Our reference: PA1042-100-100\_gwb300315-wave attenuator.docx  
Date: 8 April 2015

**Subject: CATTLE BAY MARINA – RESPONSE TO SUBMISSIONS ON EIS  
SUPPLEMENTARY STATEMENT ON WAVE ATTENUATOR AND  
POTENTIAL IMPACTS**

## **CATTLE BAY MARINA – MUSSELL FARM IMPACT ASSESSMENT**

**Figure 1** Proposed Alignment of Wave Attenuator

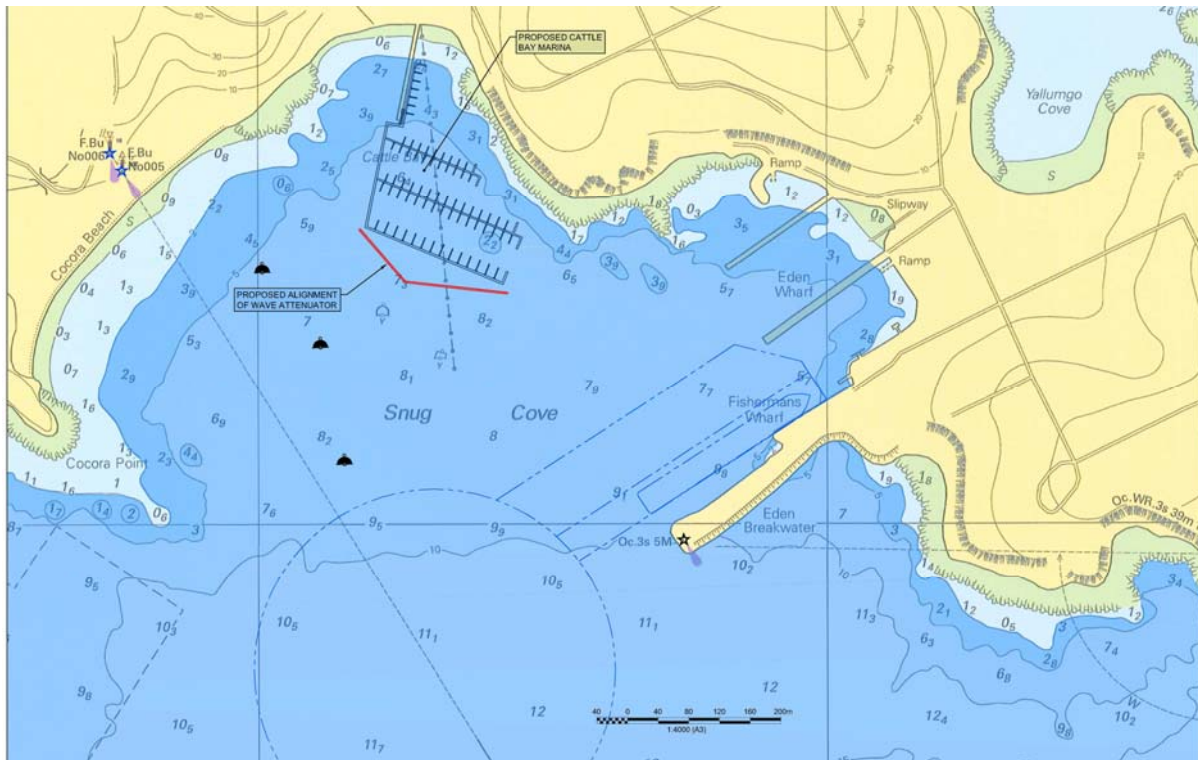
A number of submissions raised the issue of the proposed wave attenuator, including its final alignment, its potential impacts on adjacent shorelines, particularly Cocora Beach, and its potential impacts on the commercial mussel farm south and west of Cocora Point.

The proposed final alignment of the attenuator is 'cranked' rather than straight. The cranked alignment is shown in **Figure 1** and is the alignment modelled in the Cardno report 'Cattle Bay Marina, Eden – Wave Modelling' (Cardno, 28 July 2014). Accordingly, the modelling results in Cardno (2014) pertain to the wave attenuator proposed. It is not proposed or considered necessary to modify the alignment further<sup>1</sup>.

The cranked alignment has been adopted to avoid adverse impacts on Cocora Beach, as discussed further below. It is noted that a cranked alignment is preferred by Council for this reason (Council letter to Eden Resort Hotel, 18 February 2015).

**Figure 2** Mean Energy – Weighted Wave Direction Swell Waves

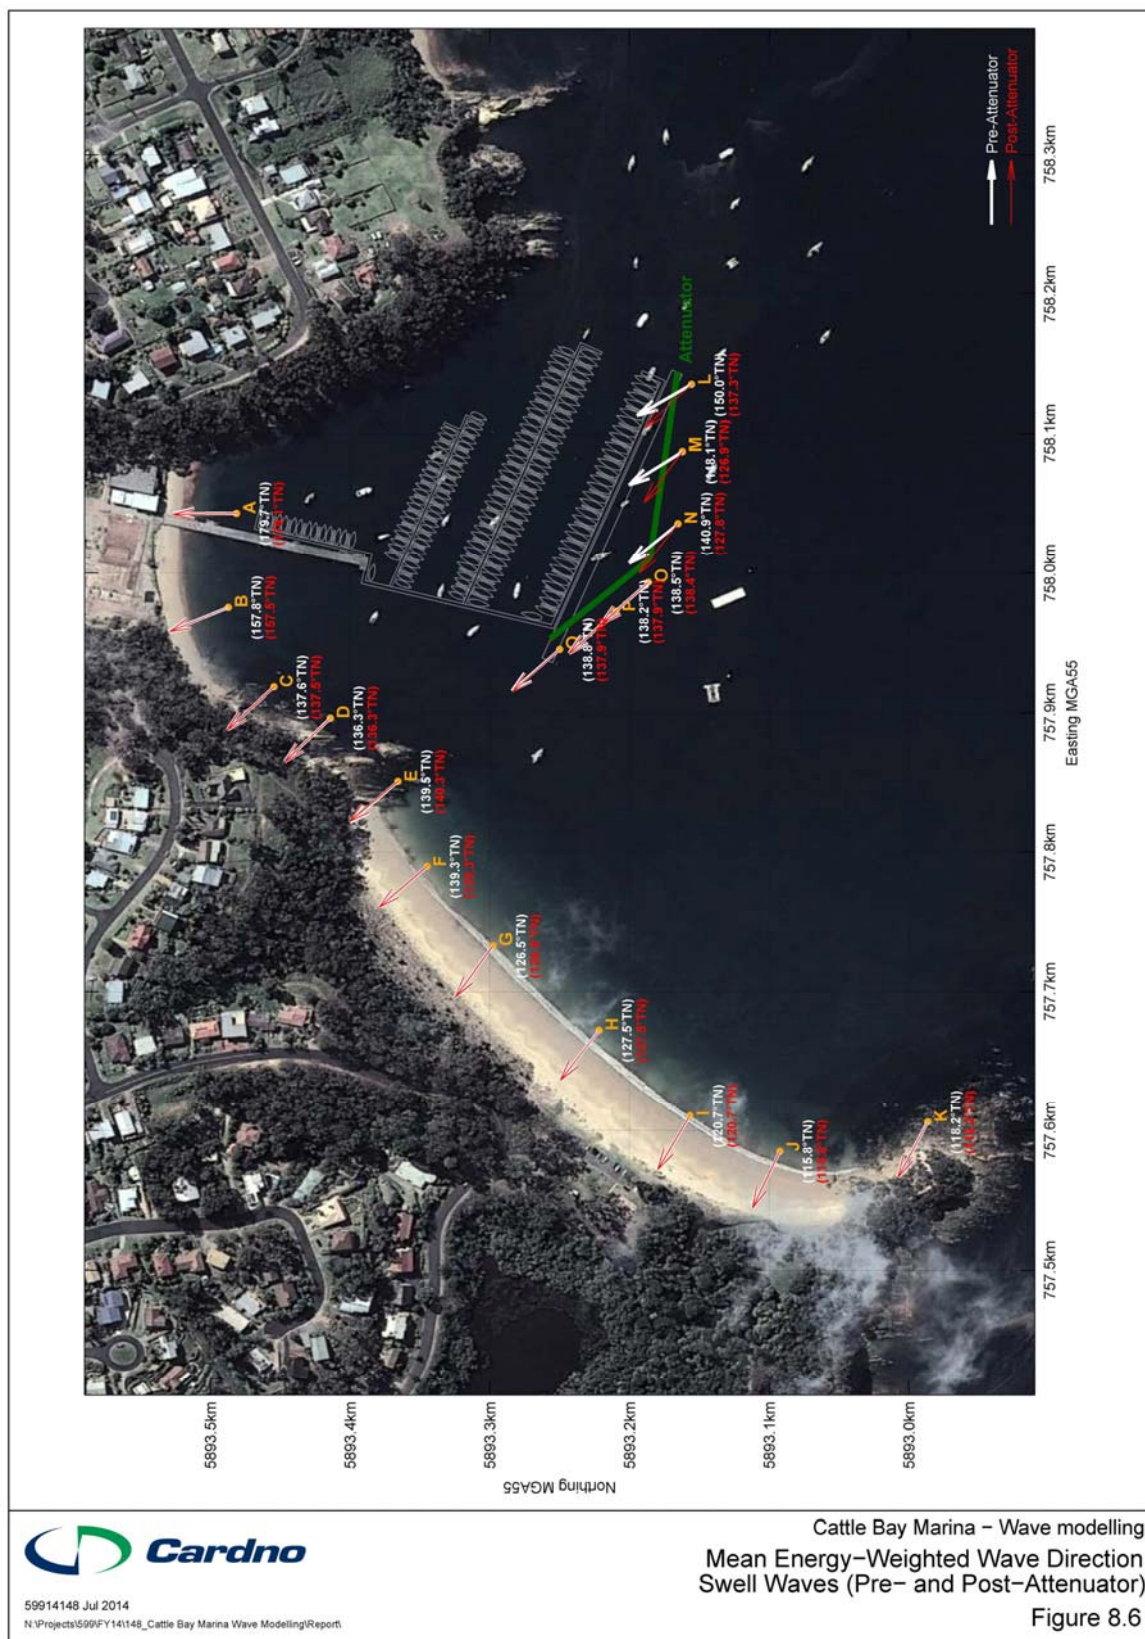
The alignment of Cocora Beach is controlled, or driven, by the approach direction of swell waves from the ocean. The low energy of the swell contributes to the beach being a safe area for swimming. It is very important that the proposed wave attenuator for Cattle Bay Marina does not impact adversely on Cocora Beach by possibly reflecting swell waves towards the beach which could affect swell wave direction along the beach (thus beach alignment) and/or swell wave energy along the beach.

The modelling by Cardno confirmed that the wave attenuator would not cause significant changes to the swell wave direction and energy along Cocora Beach since:

- the eastern section of the attenuator is aligned such that reflected swell wave energy is directed south of Cocora Beach<sup>2</sup>;
- the western section of the attenuator is well aligned with the incoming swell direction and does not cause reflection of swell waves.

**Figure 2** is a copy of Figure 8.6 from Cardno (2014) and shows the mean energy-weighted wave direction for swell waves along Cocora Beach pre and post the wave attenuator. The alignment of the wave attenuator is shown in green. **Table 1** summarises the mean energy-weighted swell wave directions along Cocora Beach pre and post the attenuator. It is apparent that there is no predicted change to swell wave direction as a result of the proposed wave attenuator.

**Figure 5 – Energy Spectral Density - Output Location MF1**

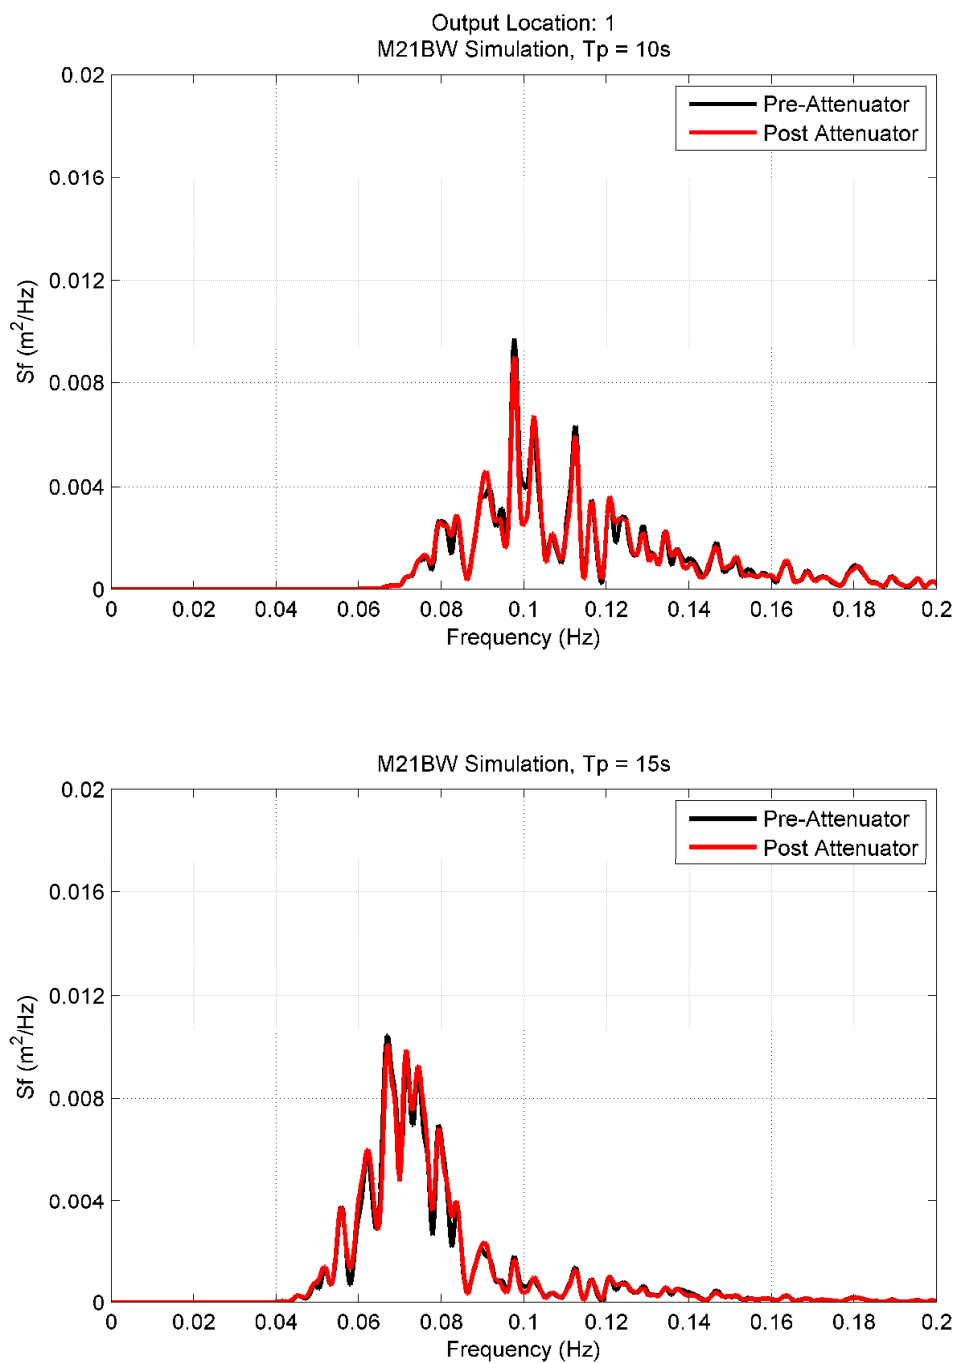
A submission to Bega Valley Shire Council by the NSW Cultured Mussel Growers Association (February 2015) has noted that too little weight has been given in the EIS to the potential impacts on mussel farm infrastructure of swell waves reflected off the wave attenuator. This infrastructure is located to the west of Cocora Point approximately 470m south-west of the proposed wave attenuator. The point made by the Association is reasonable, accordingly a specific examination has been made of this issue.

RHDHV has advised that the NSW Mussel Growers Association has prepared a submission expressing concern that the proposed wave attenuator will result in increased swell energy at the site of the Twofold Bay mussel farm, which is situated to the south of Cocora Point, and approximately 470 m south-west of the proposed wave attenuator. Consequently there is a need to undertake an assessment of the effects of the wave attenuator on the wave climate in the vicinity of the mussel farm. In March 2015 Cardno was commissioned by RHDHV to undertake this study, utilising the results of wave modelling conducted as part of the previous investigation (Cardno, 2014).

The results of the previous MIKE21 BW modelling were extracted and the energy spectral density functions were assessed for the output locations depicted in **Figure 1**, for wave periods of both  $T_p = 10s$  and  $T_p = 15s$ . These functions are depicted in **Figures 5** and **6**, and show that there is minimal observed change to the energy spectral densities at these locations. This is consistent with Figures 9.3 and 9.5 of Cardno (2014), which showed that there was only minimal change to wave coefficients for the penetration of Tasman Sea swell. These figures also indicate that only minor changes to swell wave energy in the mussel farm region would be caused by the proposed wave attenuator.

The SWAN and MIKE21 BW modelling results showed that the implementation of the wave attenuator would have only minimal effect on wave heights, directions and energy spectral density at the locations depicted in **Figure 1**. It should be noted that one of the output locations is situated outside of the mussel farm region, but *closer* to the attenuator. Consequently, it is then reasonable to purport that other locations within the mussel farm that are either as close, or farther, from the wave attenuator would be either equally or less affected.
